Access Compliance Report Public Rights-of-Way (Curb Ramps)

Main Street: KILT_AVE Cross Street: E_YORBA_LINDA_BLVD Location: SW

ADA ID: RPAT210917144037 Ramp Type: Type 1 - Perpendicular Diagonal Initial Pass/Fail: Pass Overall Compliance: No Severity Score: 7

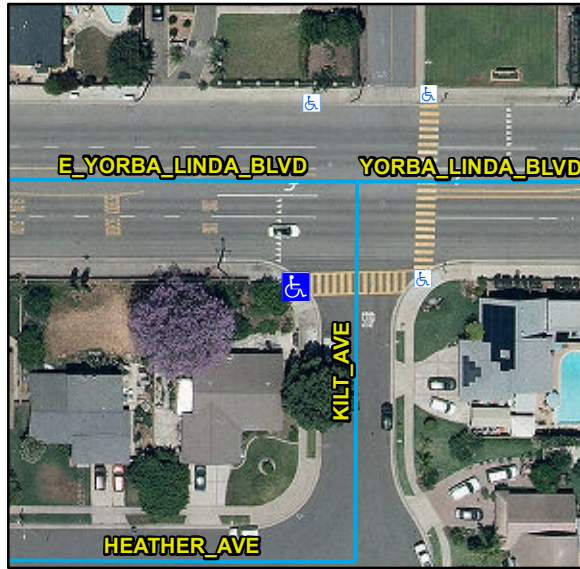
Compliance	Description	Data	Compliance	Description	Data
N/A	Ramp Length (in)	80	N/A	Flare Type LT	
Yes	Ramp Width (in)	48			Sloped
Yes	Ramp Run Slope (%)	7.8	Yes	Flare Slope LT (%)	3.5
No	Ramp Cross Slope (%)	4.5	N/A	Flare Traversable LT	Yes
N/A	Landing Present	Yes	N/A	Flare Type RT	
N/A	Landing Length (in)	52			Sloped
Yes	Landing Width (in)	48	Yes	Flare Slope RT (%)	8.2
No	Landing Run Slope (%)	3.1	N/A	Flare Traversable RT	Yes
No	Landing Cross Slope (%)	5	Yes	DWS Provided	Yes
N/A	Landing Movement Obstructed?	Yes	Yes	DWS Contrast	Yes
	Landing Movement Type	wall	Yes	DWS Length (in)	25
N/A	Landing Shared	No	Yes	DWS Full Width	Yes
N/A	Clear Space	Yes	Yes	DWS Offset Left (in)	0
N/A	Clear Space To Crosswalk (in)	48	Yes	DWS Offset Right (in)	N/A
N/A	Marked Crosswalk 1	Yes	N/A	Marked Crosswalk 2	No
	Crossing 1 Direction	E		Crossing 2 Direction	N
	Marked Crosswalk 1 Width (in)	143		Marked Crosswalk 2 Width (in)	N/A

Yes	Ramp Inside Crosswalk 1	Yes	Yes	Ramp Inside Crosswalk 2	N/A
	Crossing 1 Slope (%)	3.1		Crossing 2 Slope (%)	5.3
	Crossing 1 Cross Slope (%)	5.9		Crossing 2 Cross Slope (%)	0.4
Yes	Gutter Ponding	No	N/A	Curb Slope	4.5
Yes	Gutter Lip Height (in)	0		Road Run Slope (%)	3.7
No	Gutter Run Slope (%)	5.9		Road Cross Slope (%)	4
No	Gutter Cross Slope (%)	4.7			
Yes	Overall Surface Condition: Acceptable		Yes	Perp Joint Present	Yes
	Cross Gutter Present?	No		Spandrel Present?	No
	Replace Cross Gutter?	N/A		Replace Spandrel?	N/A

Remove & Replace Curb Ramp With Two New Directional Ramps or Equivalent. Remove & Replace Gutter.
